Working Draft American National Standard

Project T10/1760-D

Information technology - Serial Attached SCSI - 2 (SAS-2)

Summary of Comments on Serial Attached SCSI - 2 (SAS-2) Standard

Figure 40 — Reset terminology

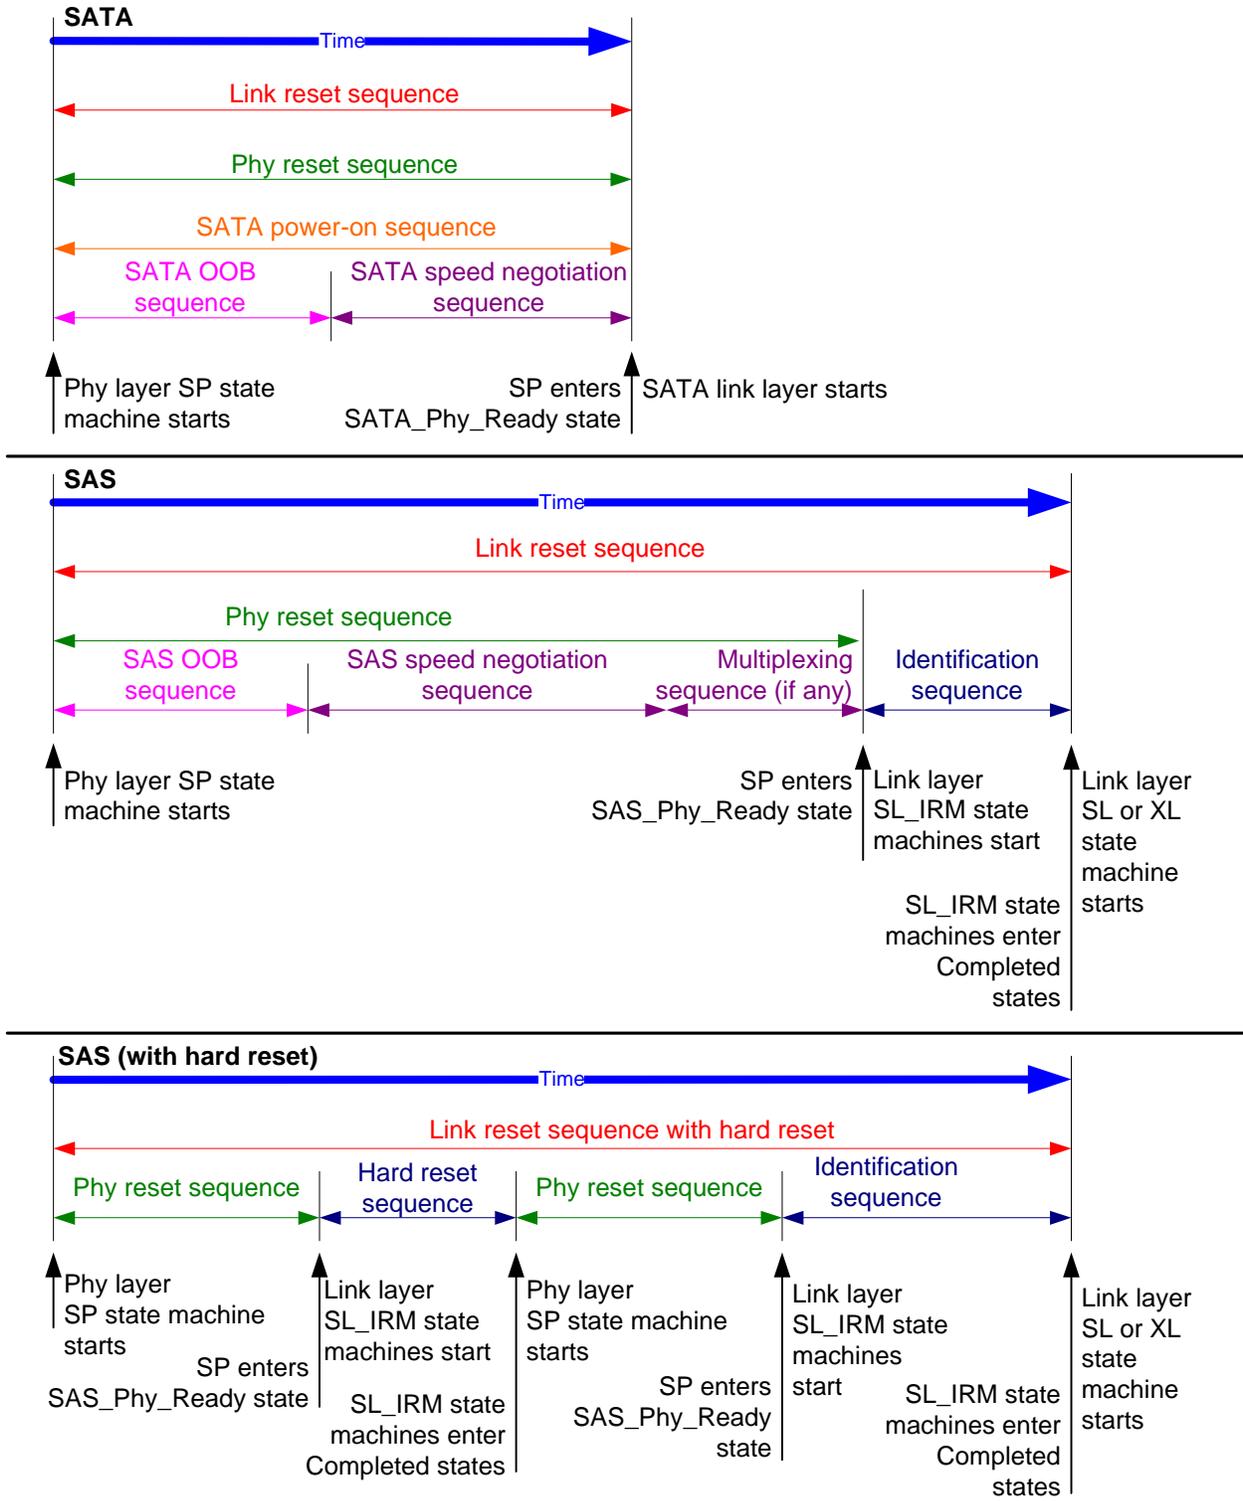
T ACCEPT - DONE (7/15 global change "illustrates" to "shows" in cases like this.)

Figure 50 — Expander route index order example

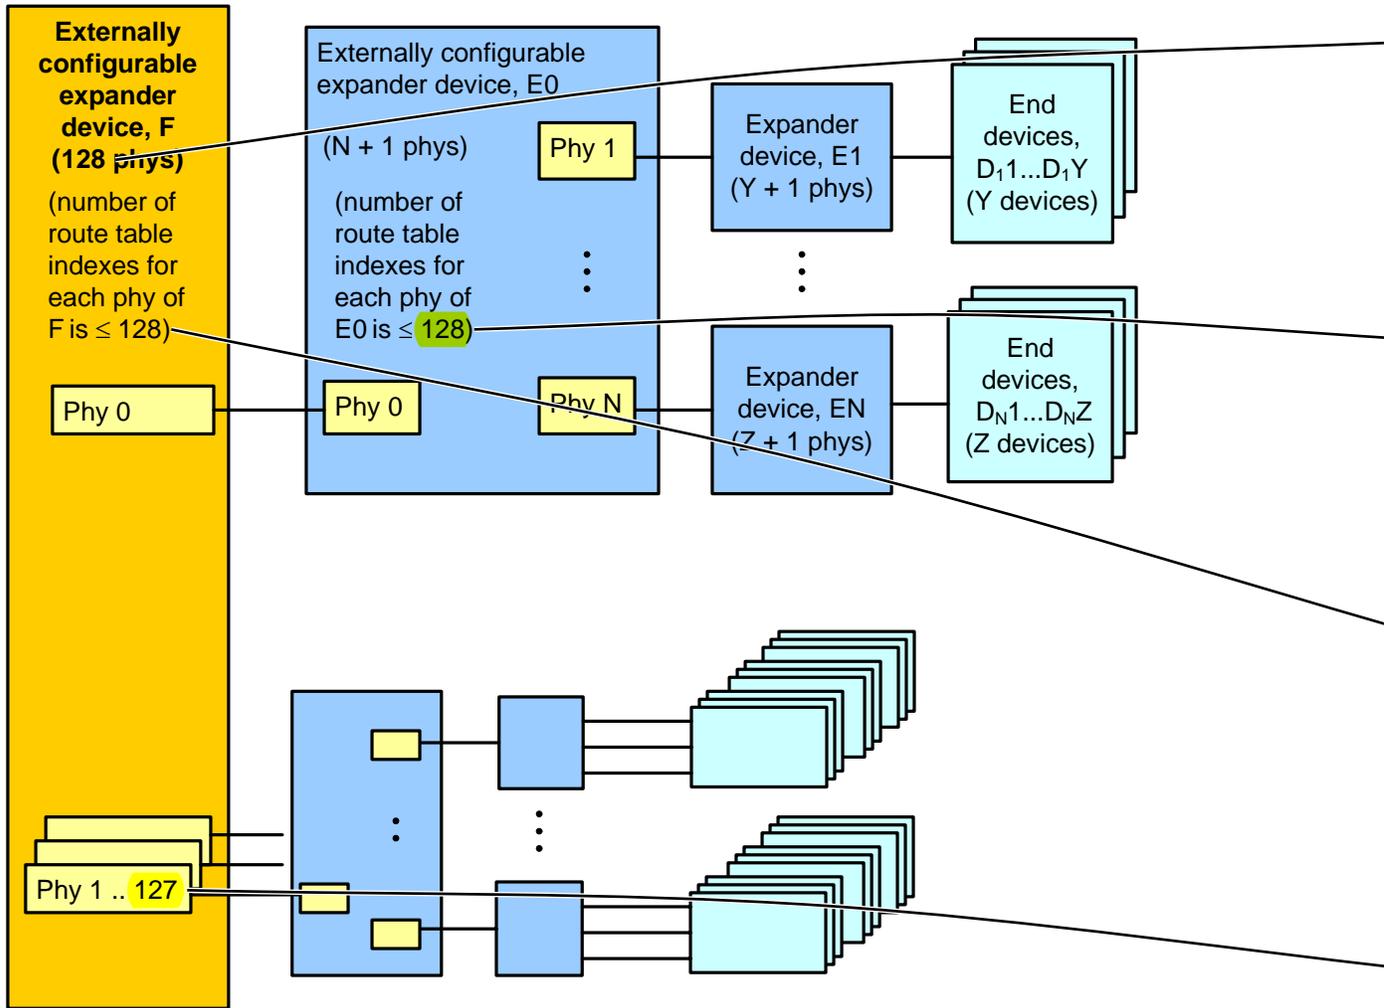
in figure 50, not table 50: 128 to 255, deleted two unnecessary sentences

Figure 157 — SP (phy layer) state machine - SATA host emulation states

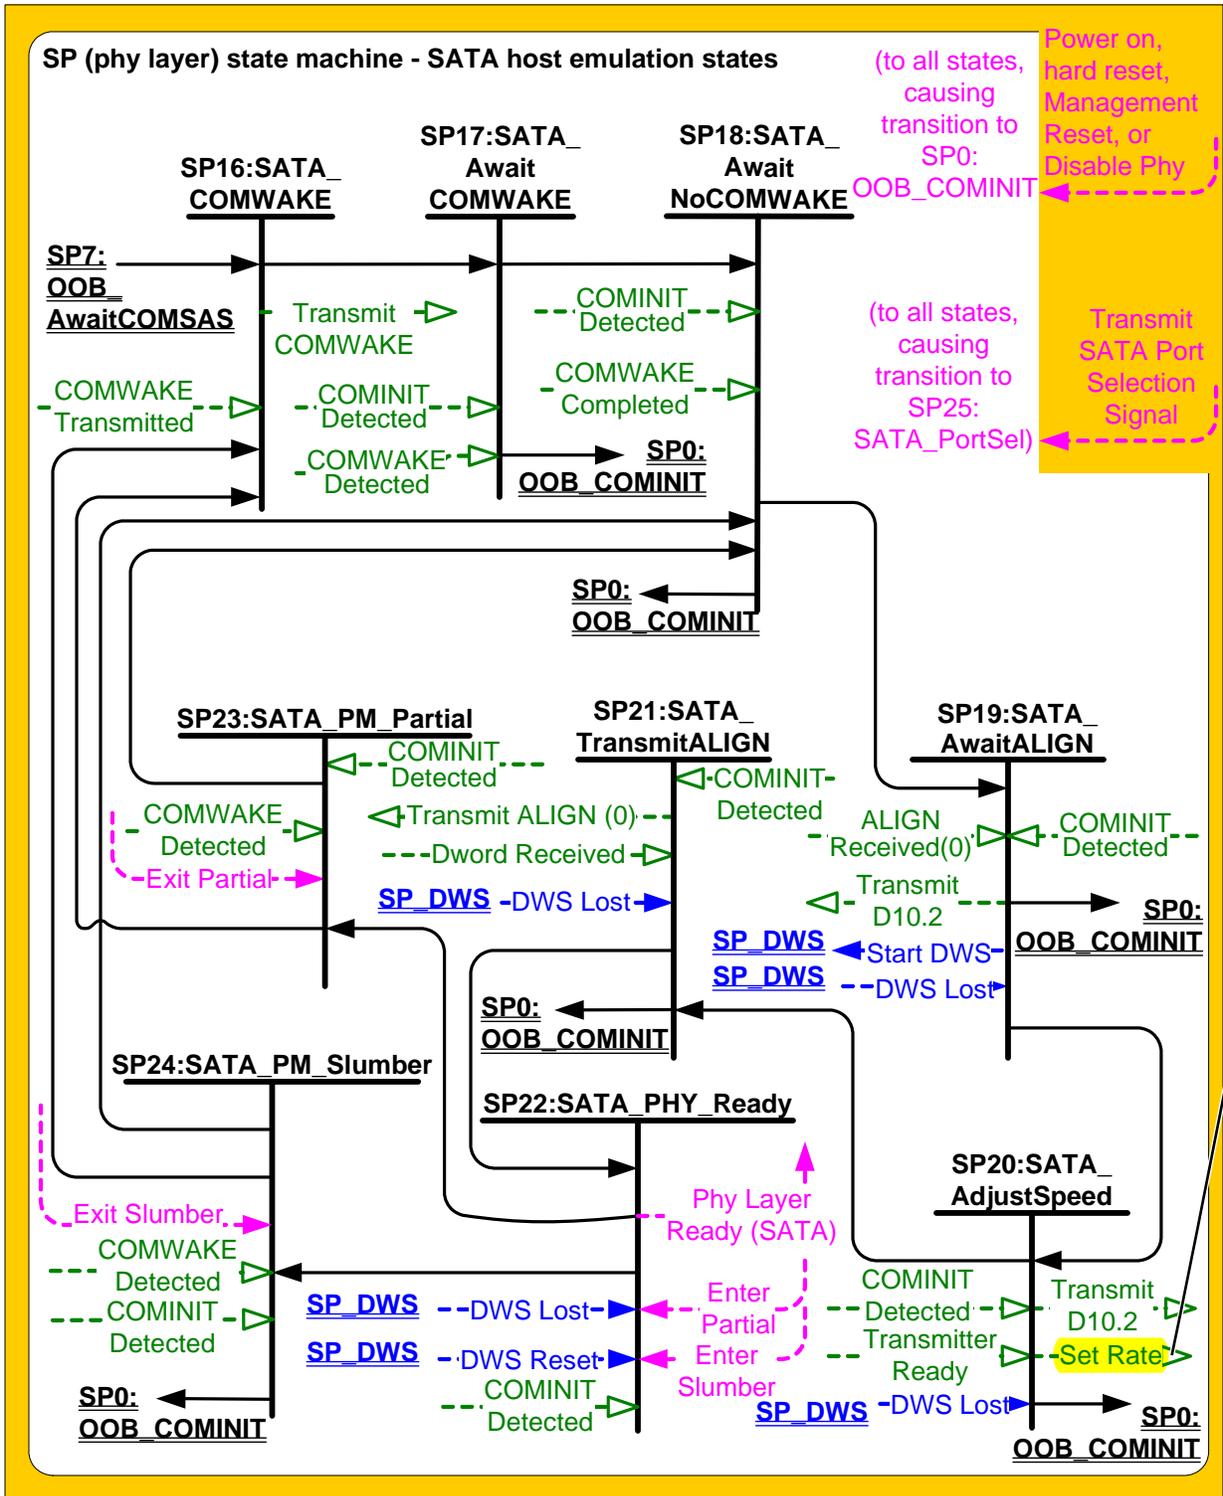
Delete "in this standard" which is awkward wording
